# Access Compliance Report

## Public Rights-of-Way

### (Curb Ramps)

Intersection ID: 53270	Main Street: MONROE_RD	Cross Street: MERIDIAN_CENTER_DR	Location: SE
ADA ID: D81A347A1BEB	Ramp Type: Para	Initial Pass/Fail: Fail	Overall Compliance: No
Codes/Mitigation Info/Possible Solution		Field Measurements/Component Compliance	
Severity Score: 12.5

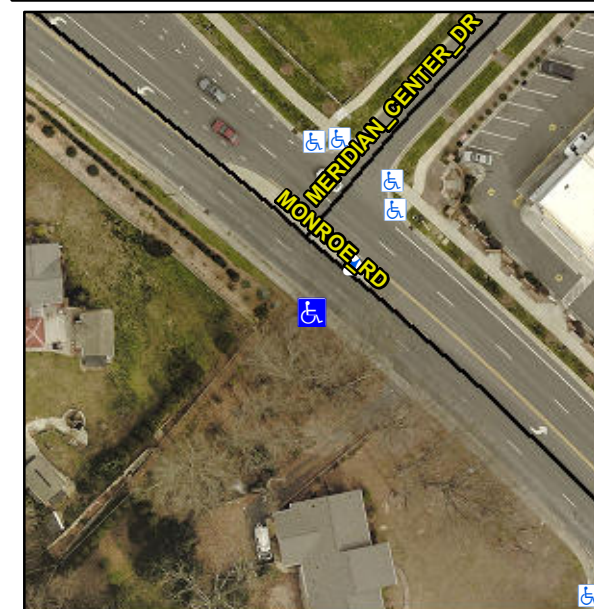
Compliance	Description	Data	Compliance	Description	Data
N/A	Ramp Length LT (in)	36.0	N/A	Ramp Length RT (in)	36.0
Yes	Ramp Width LT (in)	60.0	Yes	Ramp Width RT (in)	60.0
No	Ramp Slope LT (%)	9.0	Yes	Ramp Slope RT (%)	5.0
Yes	Ramp XSlope LT (%)	1.8	Yes	Ramp XSlope RT (%)	0.8
N/A	Landing Length (in)	N/A	N/A	DWS Provided?	N/A
N/A	Landing Width (in)	N/A	N/A	DWS Contrast?	N/A
N/A	Landing Slope (%)	N/A	N/A	DWS Length (in)	N/A
N/A	Landing X Slope (%)	N/A	N/A	DWS Full Width?	N/A
N/A	Landing Curb? (Y/N)	N/A	N/A	DWS Offset (in)	N/A
N/A	Shared Landing?	N/A			
N/A	Gutter Ponding?	N/A	N/A	Gutter Slope (%)	N/A
N/A	Gutter Lip Ht (in)	N/A	N/A	Gutter X Slope (%)	N/A
N/A	Painted X Walk1?	No	N/A	Painted X Walk2?	N/A
	X Walk 1 Direction	To NE		X Walk 2 Direction	N/A
N/A	X Walk 1 Width (in)	N/A	N/A	X Walk 2 Width (in)	N/A
	X Walk 1 Slope (%)	7.0		X Walk 2 Slope (%)	N/A
	X Walk 1 X Slope (%)	1.9		X Walk 2 X Slope (%)	N/A
N/A	Ramp inside XWalk1?	N/A	N/A	Ramp inside XWalk2?	N/A

**Remove & Replace Entire Ramp.**
